**Re: Broadstone Promenade Phase 15 & 12
7400 San Pedro Dr. NE
Permanent CO – Accepted
Engineer's Stamp dated: 5-26-15 (D18D054A)
Certification dated: 3-23-16**

Based upon the information provided in your submittal received 3/24/2016, the above referenced Certification received is acceptable for the release of Certificate of Occupancy by Hydrology.

DRAINAGE CERTIFICATION

OVERALL  
GRADING AND DRAINAGE PLAN

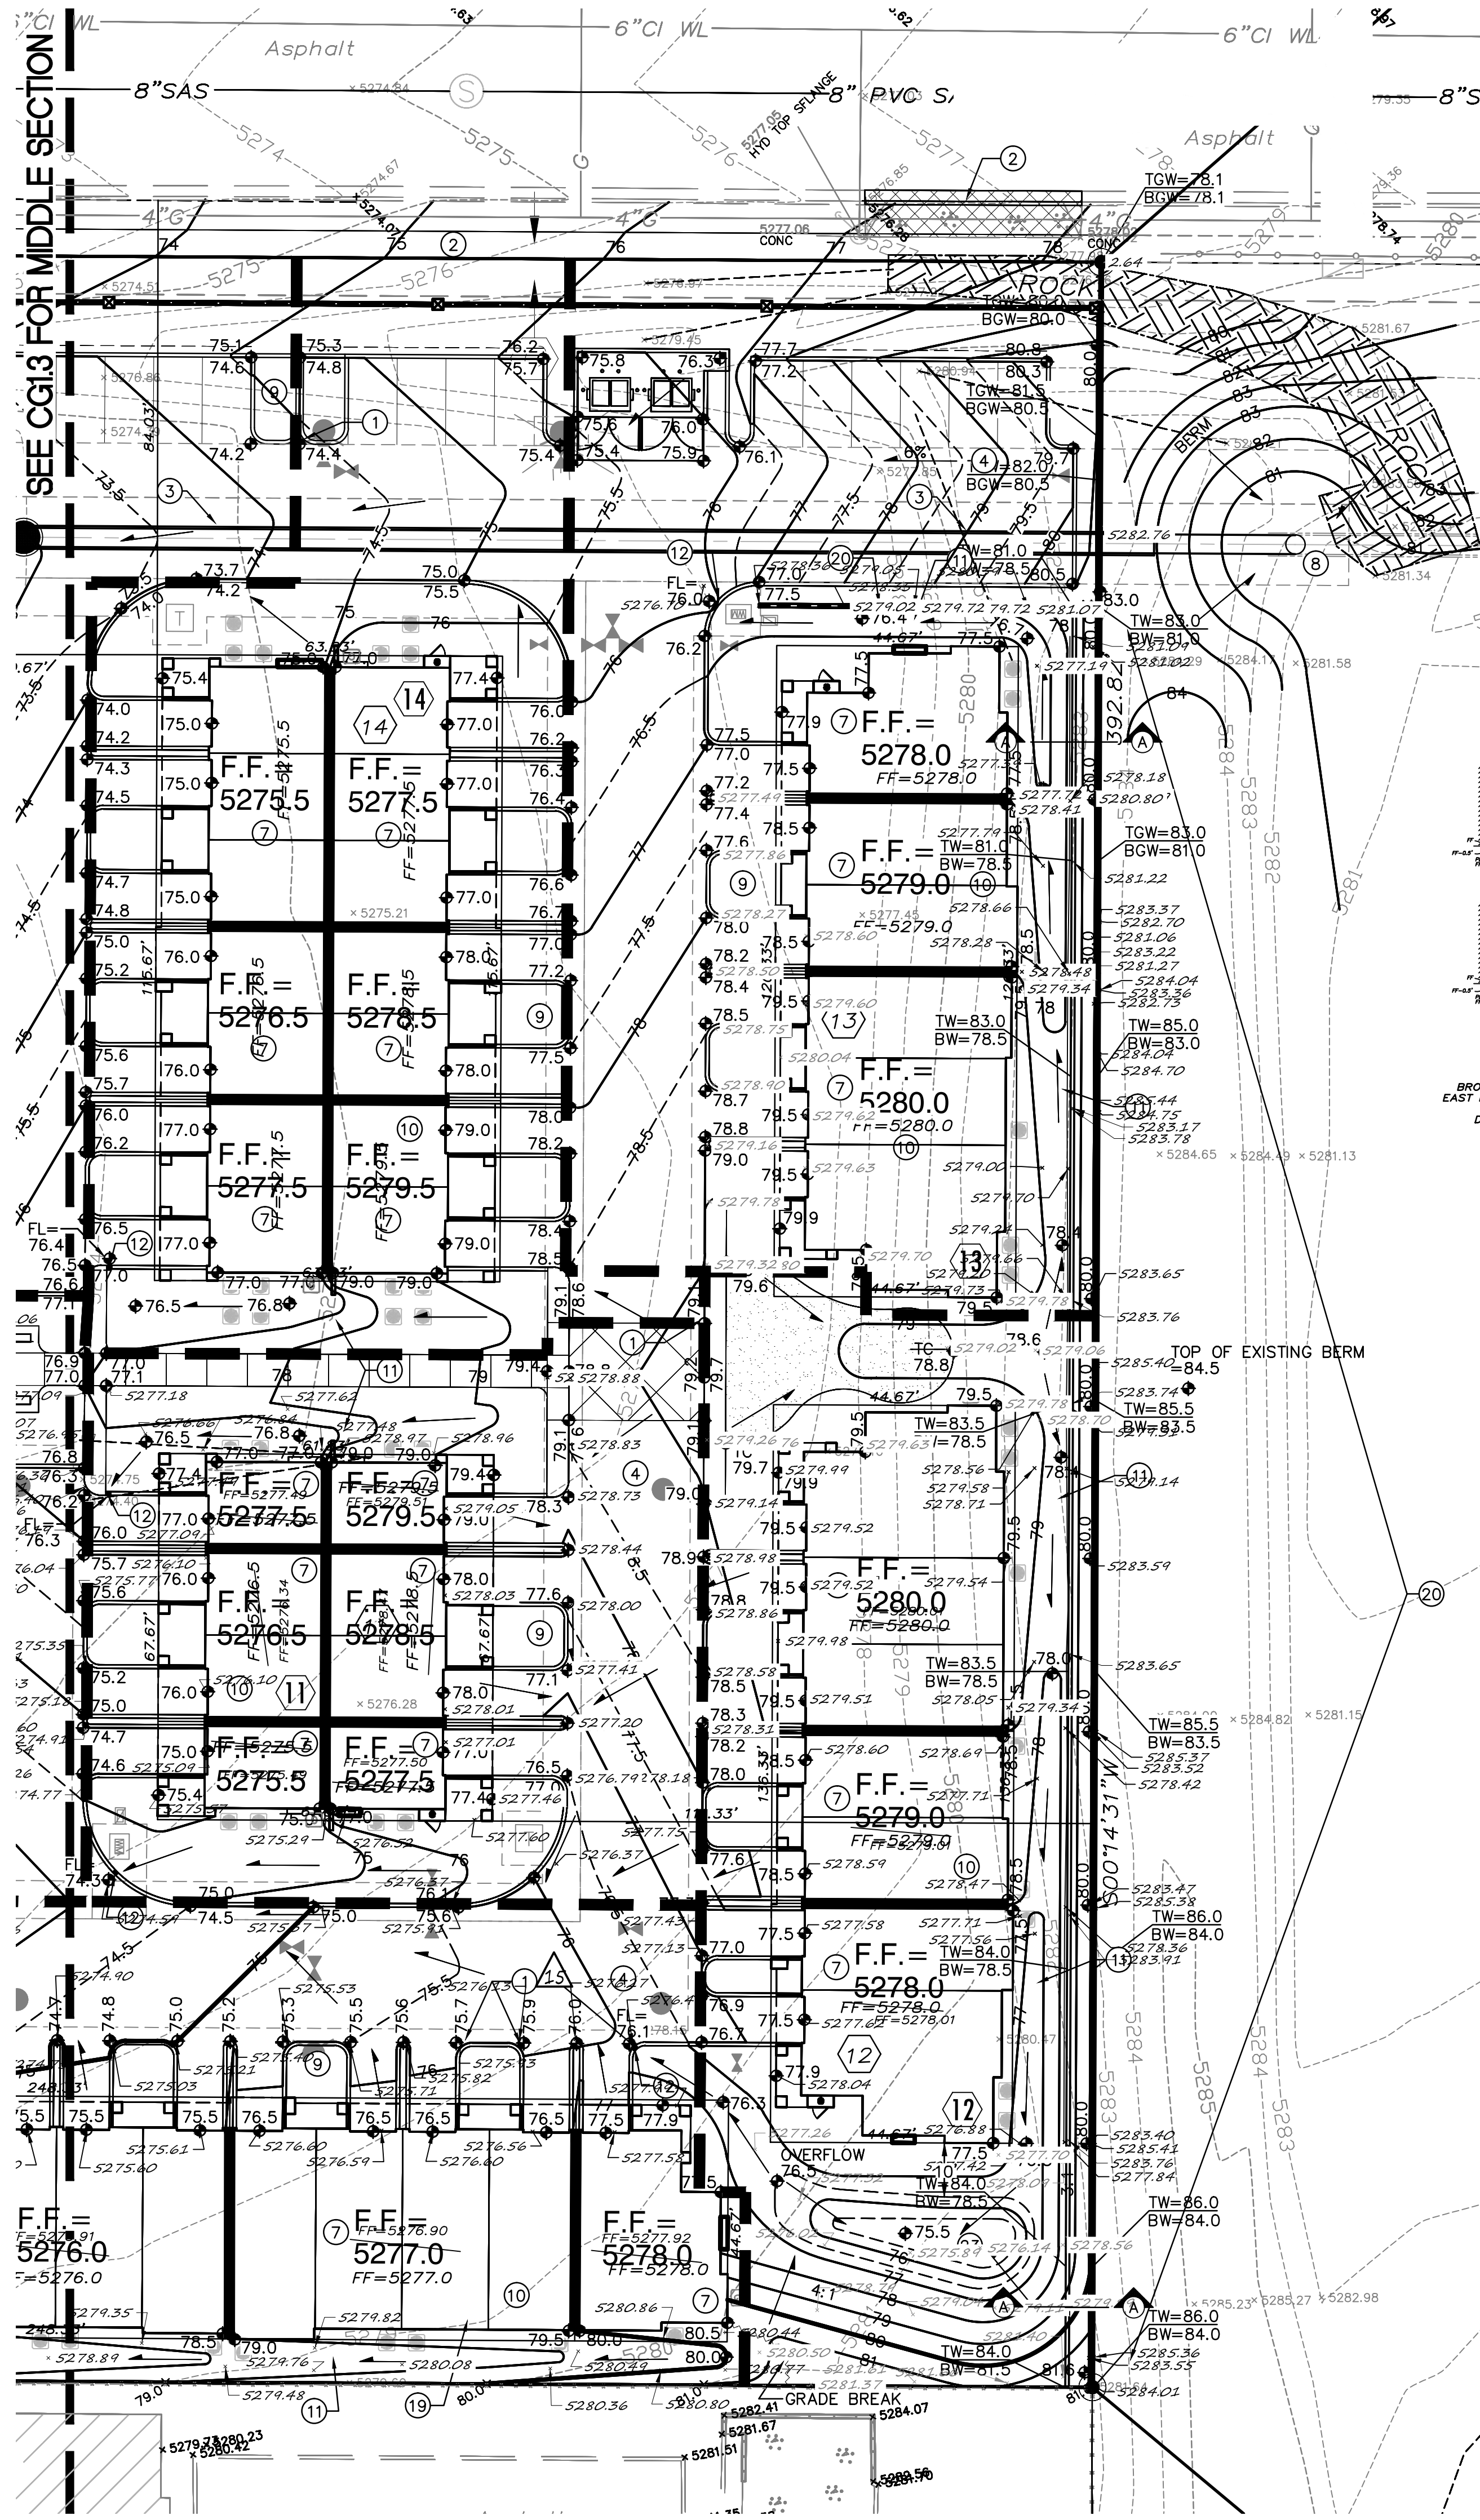
- △ SIDEWALK CULVERT NOT CONSTRUCTED. CULVERT SHALL BE CONSTRUCTED PRIOR TO CERTIFICATION OF BUILDING 2.

- △ LOWER/ADJUST STORM DRAIN GRATES TO GRADE, TO BE VERIFIED PRIOR TO CERTIFICATION OF PHASE 3.

- △ INSTALLATION OF SIDEWALK CULVERT OR PVC PIPES TO BE VERIFIED PRIOR TO CERTIFICATION OF PHASE 4.

- △ GRADING OF SLOPE TO BE VERIFIED PRIOR TO CERTIFICATION OF PHASE 4.

- △ COMPLETION OF ITEMS FROM PHASES 3 & 5 TO BE VERIFIED PRIOR TO FINAL CERTIFICATION.

- △ INSTALLATION OF 4" PVC PIPES TO BE VERIFIED PRIOR TO FINAL CERTIFICATION.

- △ LANDSCAPING TO BE ADJUSTED SUCH THAT A SWALE DIRECTS STORM WATER TO PIPES OR SIDEWALK CULVERTS AND THAT TOP OF MATERIAL IS AT INVERT OF PIPE OR CULVERT TO ALLOW FOR FLOW THROUGH. UNDER NO CIRCUMSTANCES SHOULD THE ENDS OF PIPES OR CULVERTS BE BURIED. THIS SHALL BE VERIFIED PRIOR TO FINAL CERTIFICATION.

- △ OBTAIN ADDITIONAL AS-BUILT SPOTS TO ALLOW FOR VERIFICATION OF DRAINAGE PATHS AND SLOPES PRIOR TO FINAL CERTIFICATION.

- △ GRADE A DEFINED SWALE/OVERFLOW PATH TO BOTTOM OF SIDEWALK CULVERT AND LINE SWALE WITH FRACTURED FACE ROCK. TOP OF ROCK ELEVATION SHALL BE AT INVERT OF CULVERT.

- △ LOWER INLET 0.5'.

- △ CONSTRUCTION OF ITEMS 8 & 9 SHALL BE COMPLETED BEFORE CERTIFICATION OF PHASE 7.

- △ 4" PIPES INSTALLED THROUGH SIDEWALKS.

- △ RIM ELEVATION OF INLET (ITEM 8) SHALL BE VERIFIED PRIOR TO FINAL CERTIFICATION.

- △ SIDEWALK CULVERT SHALL BE CONSTRUCTED PRIOR TO PHASE 10 CERTIFICATION.

- △ DRAIN PIPES SHALL BE INSTALLED PRIOR TO PHASE 10 CERTIFICATION.

- △ CHIPPED SIDEWALK CONCRETE AND DEFORMED DRAINAGE PIPES. DRAIN PIPES SHALL BE REINSTALLED PRIOR TO FINAL CERTIFICATION.

- △ SIDEWALK MODIFICATION AND SIDEWALK CULVERT RELOCATION.

- △ CURB OPENING NOT INSTALLED--NOT NEEDED AFTER THE SIDEWALK MODIFICATION AND SIDEWALK CULVERT RELOCATION.

- △ 2 DRAIN PIPES INSTALLED

- △ STEP NOT CONSTRUCTED

- △ 12" VALLEY GUTTER CONSTRUCTED
